# Team Update 03

# Team Update 02

# Team Update 01

Figure 3-4: The SCALE (Note, cable protectors are shown, but are not part of the SCALE)

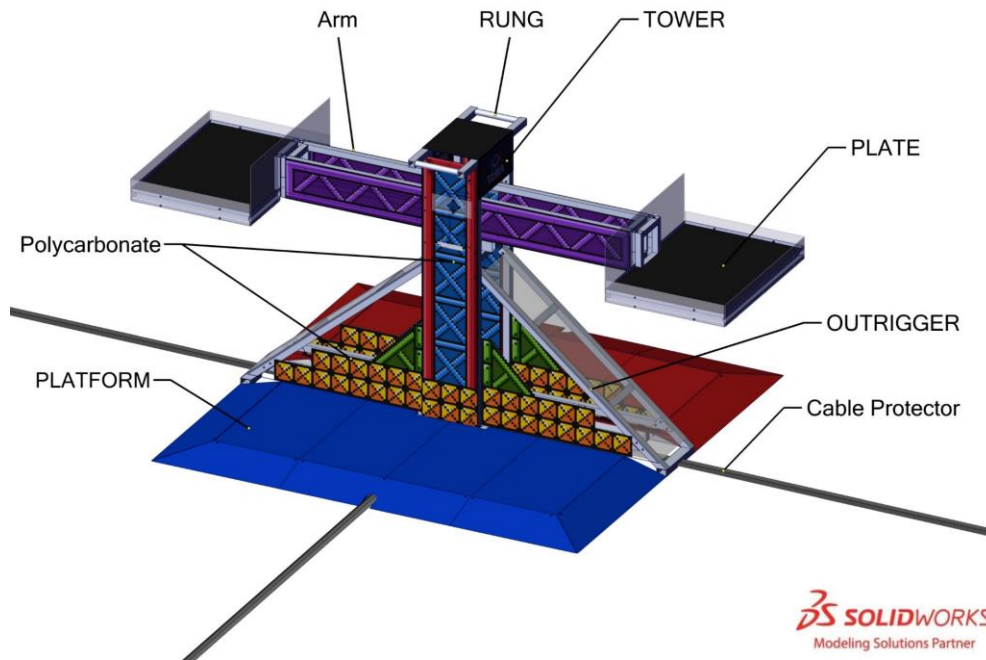
The BRICKS are graphics depicting golden squares surrounded by a black outline that extends 12 in. (~30cm) above the **horizontal** surface of the PLATFORM.

Figure 3-11: PLATFORM top length and width dimensions

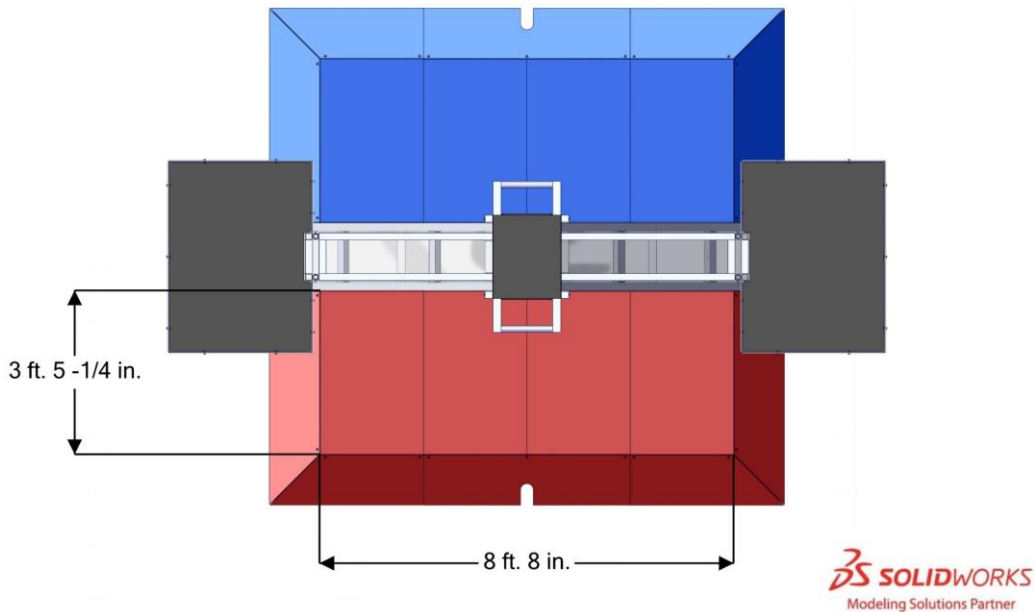
Located at the base of the SCALE, on each side, is a PLATFORM covered with ALLIANCE colored HDPE. The TOWER and OUTRIGGERS separate one PLATFORM from the other. Each PLATFORM top is 8 ft. 8 in. (~264 cm) wide by 3 ft. 5 ¼ in. (~105 cm) deep and 3 ½ in. (~9 cm) tall. The ramps leading to the PLATFORM includes ramps with a run of 1 ft. 4 ¾ in. (~33 32 cm) and long with a 15.35 deg. angle. The ALLIANCE colored tape that abuts the PLATFORM ramps is part of the PLATFORM.

Figure 4-1 Possible PLATE assignments

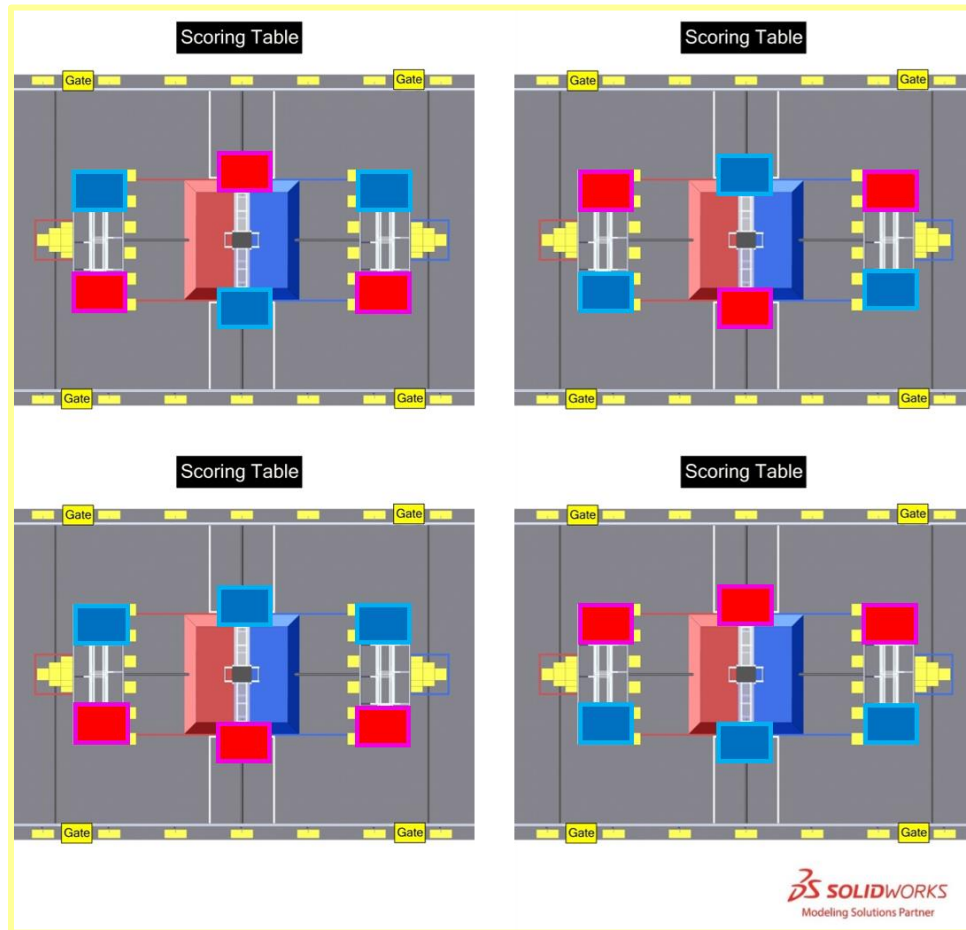
Each MATCH is divided in to two stages. The first stage, called Autonomous (AUTO), is the first fifteen (0:15) seconds of a MATCH in which ROBOTS operate without any DRIVE TEAM control or input. Prior to the start of AUTO, the assignments of ALLIANCE colors for SWITCH and SCALE

PLATES are randomized among the four states in Figure 4-1 and transmitted to the OPERATOR CONSOLE by the Field Management System (FMS). During AUTO, ROBOTS attempt to deliver preloaded POWER CUBES to PLATES, retrieve additional POWER CUBES from around the FIELD, and cross their AUTO LINE any time before the end of the stage.
